TECHNICAL BULLETIN

429-21-65

MODEL AFFECTED: 429

SUBJECT: MISSING DECALS ON FIREWALL 429-069-101-187, INSPECTION AND INSTALLATION OF

Figure 1 –Missing Decal on Forward Firewall

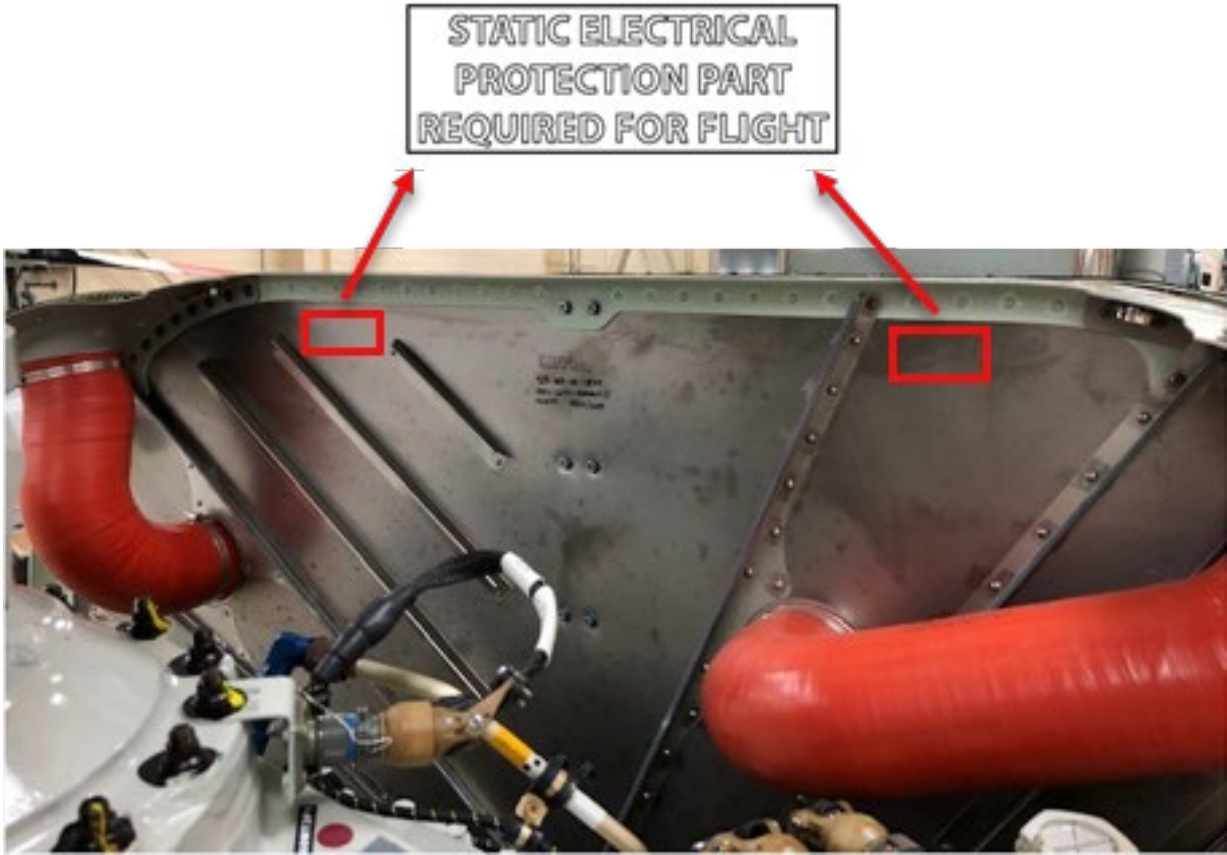
Bell recently discovered that two decals 31-055-19DMHP may have been inadvertently omitted from the forward firewall 429-069-101-187 during manufacturing. This Technical Bulletin (TB) provides procedures to inspect for the required decals and install if missing. The purpose of these decals is to remind operators that access panels 429-061-201-101 and -103 are static electrical protection parts and are required for flight. The approved engineering configuration requires these decals to be installed on the adjacent structure of the access panels, which is the subject firewall.

1. Prepare the helicopter for maintenance.
2. Remove the transmission cowl assembly 600EL and 600ER. (DMC-429-A-53-00-00-46A-520A-A)
3. Check for the presence of two decals 31-055-19DMHP on the forward firewall 429-069-101-187 per figure 1. If the decals are present, go to step 5.

Locations of the decals are shown in figure 1. They need to be clearly visible after installation. The receiving surface must be free of dirt, grease, wax and other contaminants.

4. Install two decals onto the forward firewall 429-069-101-187. (DMC-429-A-11-00-00-00A-067A-A)
5. Reinstall the transmission cowl assembly 600EL and 600ER. (DMC-429-A-53-00-00-46A-520A-A)
6. Make an entry in the helicopter logbook and historical service records indicating compliance with this Technical Bulletin.
